**CITY OF MILWAUKEE**  
**DEPARTMENT OF PUBLIC WORKS**  
**MILWAUKEE WATER WORKS**

**ADDENDUM NO. 1**

Official Notice No. 144-2010  
Location: Howard Avenue Purification Plant  
HP-176: Administration Building Roof Replacement

**ADMINISTRATION BUILDING ROOF REPLACEMENT**  
**ROOF DETAILS**

1  
02 SNAP-ON COPING CAP W/SURFACE MOUNTED COUNTERFLASHING  
NOT TO SCALE

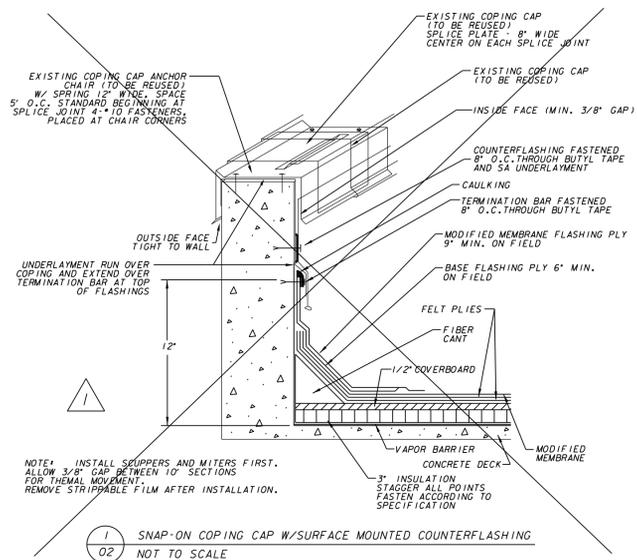
REMOVE     "7. Remove and reinstall metal coping cap on the Chemical Building & Penthouse parapet wall perimeter, and furnish & install counter-flashing, as detailed in the Contract Drawings."

INSERT       "7. Reuse metal coping cap on the Chemical Building & Penthouse parapet wall perimeter, and furnish & install counter-flashing, as detailed in the Contract Drawings.”

**CANOPY AND ROOF PLAN - CHEMICAL BUILDING**  
 1/8" = 1'-0"

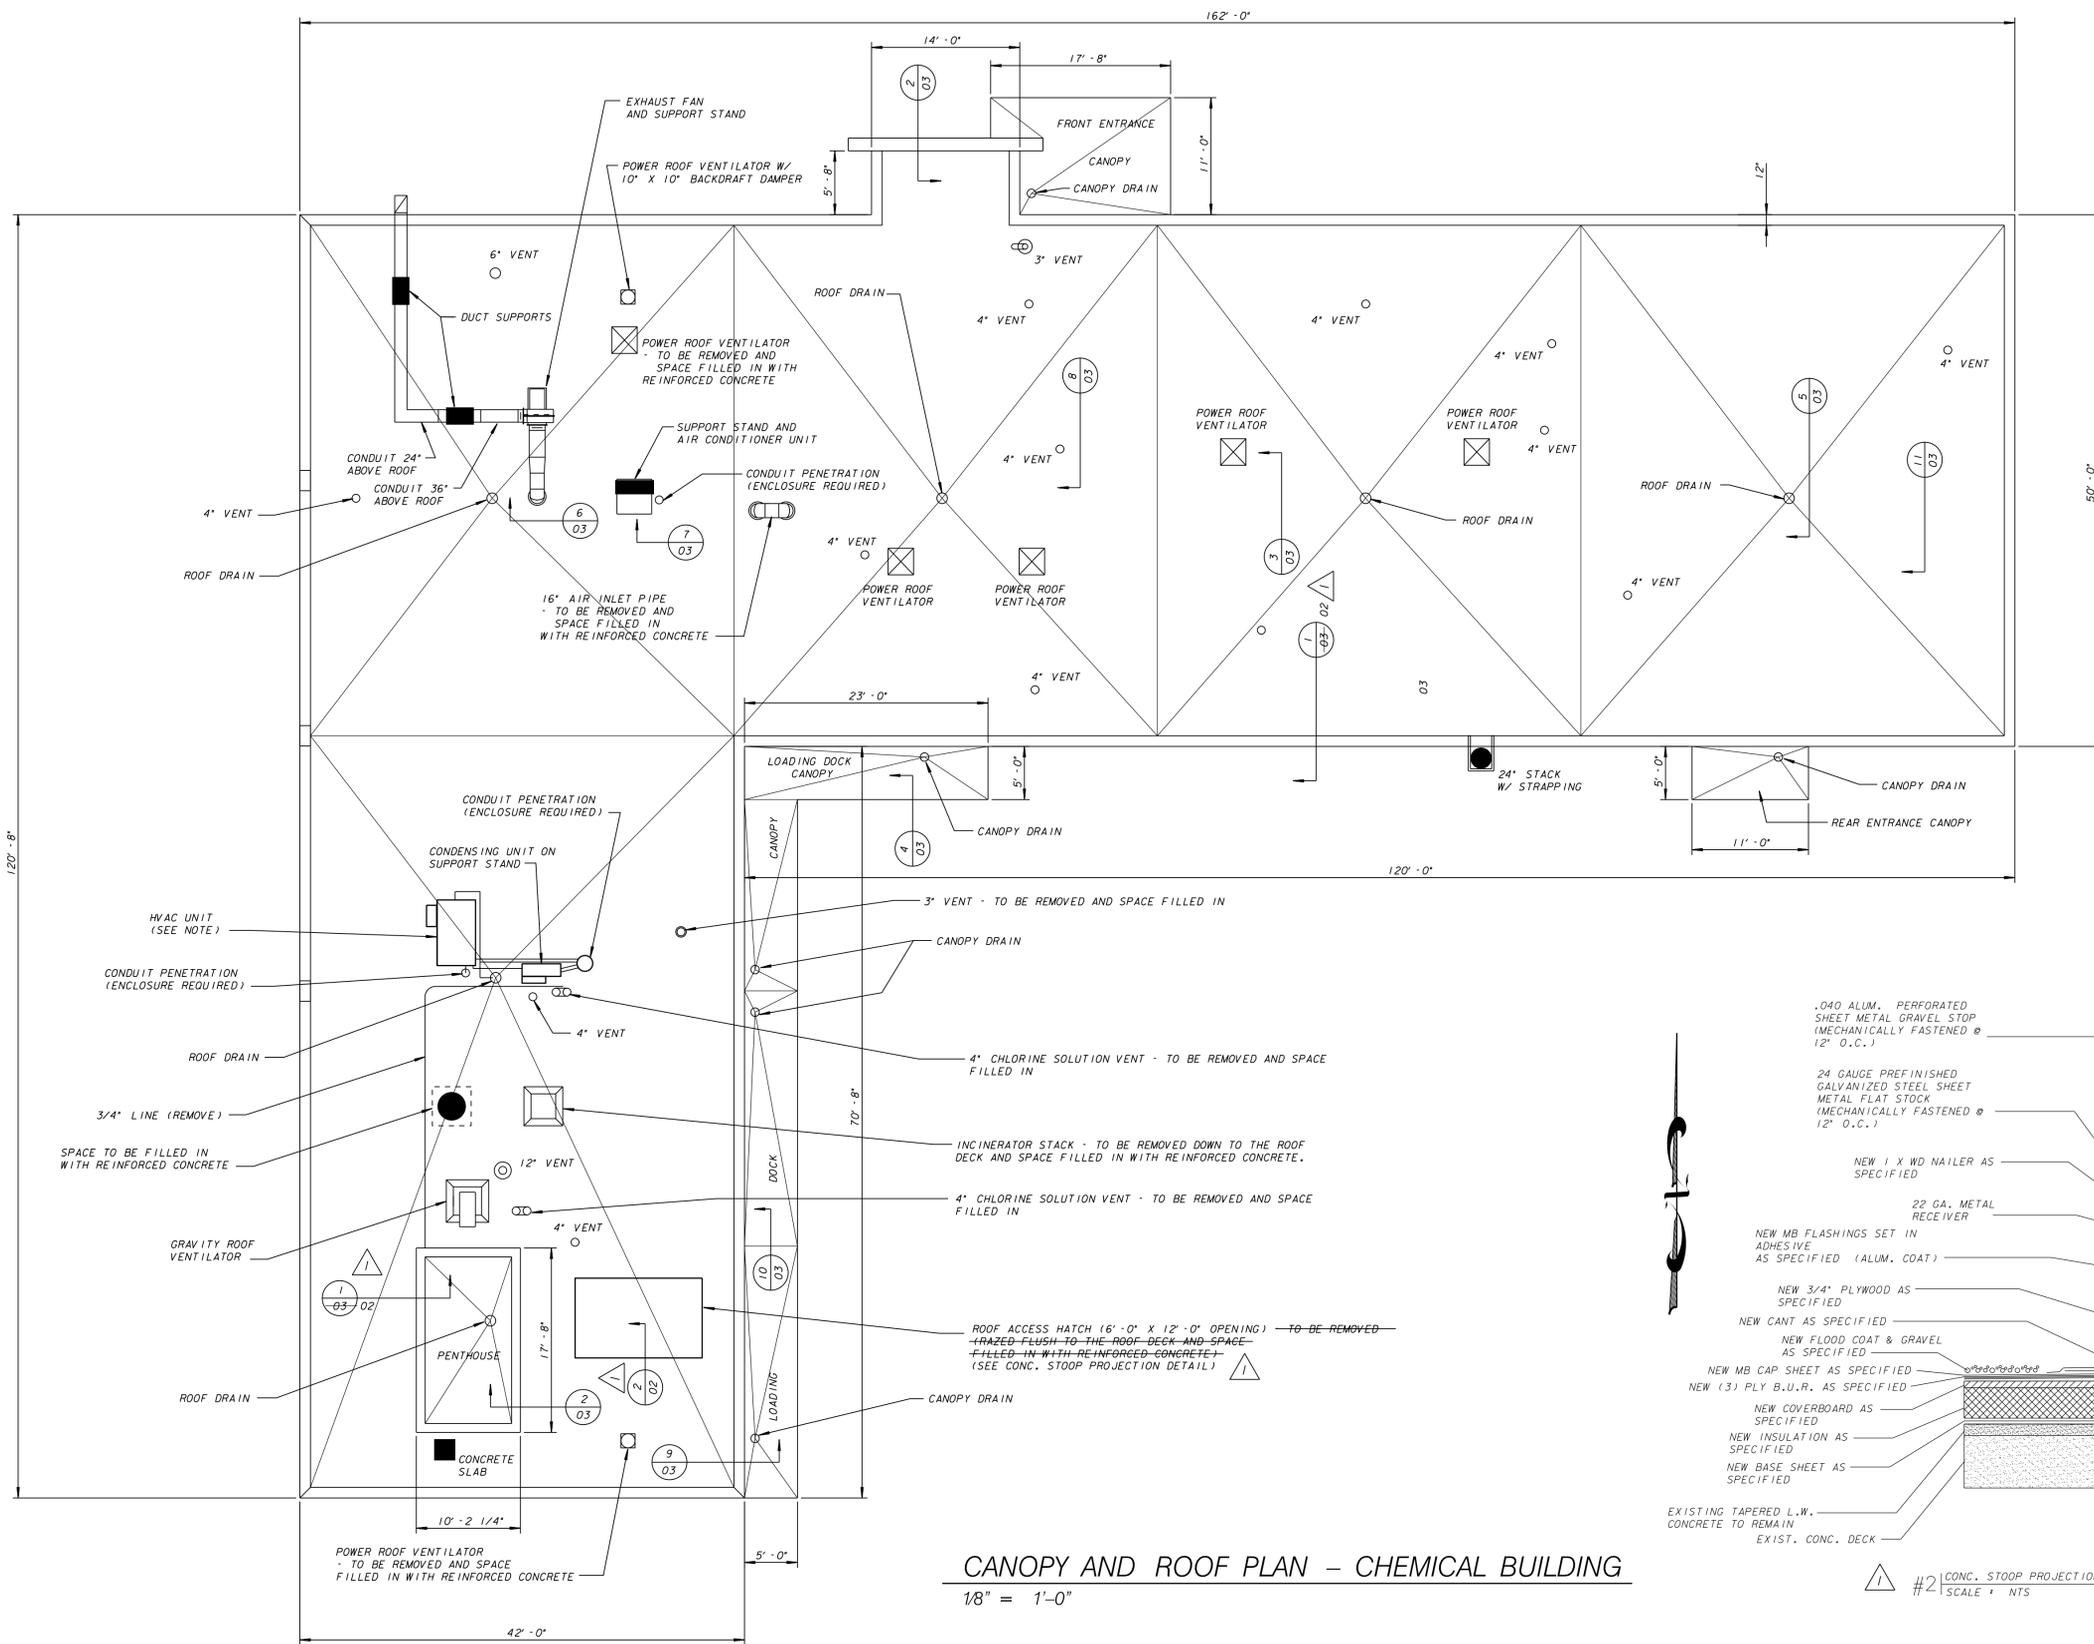
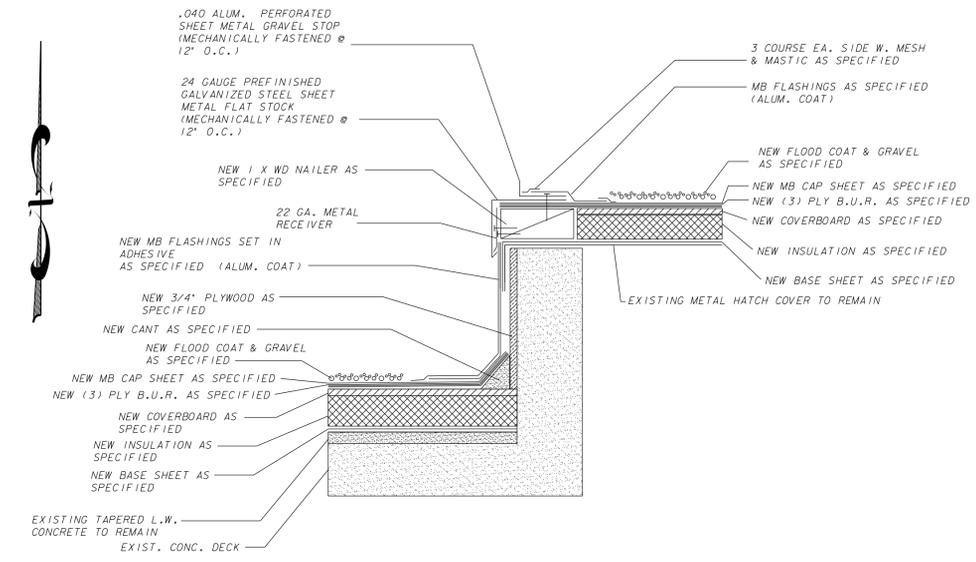
- NOTES:**
- REMOVE AND DISPOSE OF THE EXISTING EPDM SHEET MEMBRANE AND UNDERLYING BUILT-UP ROOFING SYSTEM, INCLUDING INSULATION, CANT STRIPS, FLASHING ETC.
  - FURNISH AND INSTALL A COMPLETE, HOT APPLIED ASPHALT BUILT-UP ROOFING SYSTEM.
  - PARAPET CAPPING (ROOF AND PENTHOUSE) TO BE REUSED ~~REMOVE AND RE-INSTALL~~
  - REMOVE AND REPLACE ROOF CURBS FOR ALL ROOF VENTILATOR UNITS (6 TOTAL).
  - ALL ITEMS CALLED OUT TO BE REMOVED MUST BE RAZED FLUSH WITH THE ROOF DECK.
  - ALL DESIGNATED SPACES TO BE FILLED IN SHALL BE COMPLETED USING CONCRETE REINFORCEMENT INTEGRAL TO THE SURROUNDING ROOF DECK.
  - ENCLOSURES, WITH ASSOCIATED PLIES & FLASHING, SHALL BE CONSTRUCTED WHERE CONDUIT PROTRUDES THROUGH ROOF DECK (3 LOCATIONS).
  - HVAC UNIT TO BE LIFTED, IF NECESSARY, TO PROPERLY INSTALL PLIES & FLASHING.
  - REPAIR AND/OR REPLACE ROOF DRAIN AND CANOPY DRAIN PARTS AS NECESSARY.
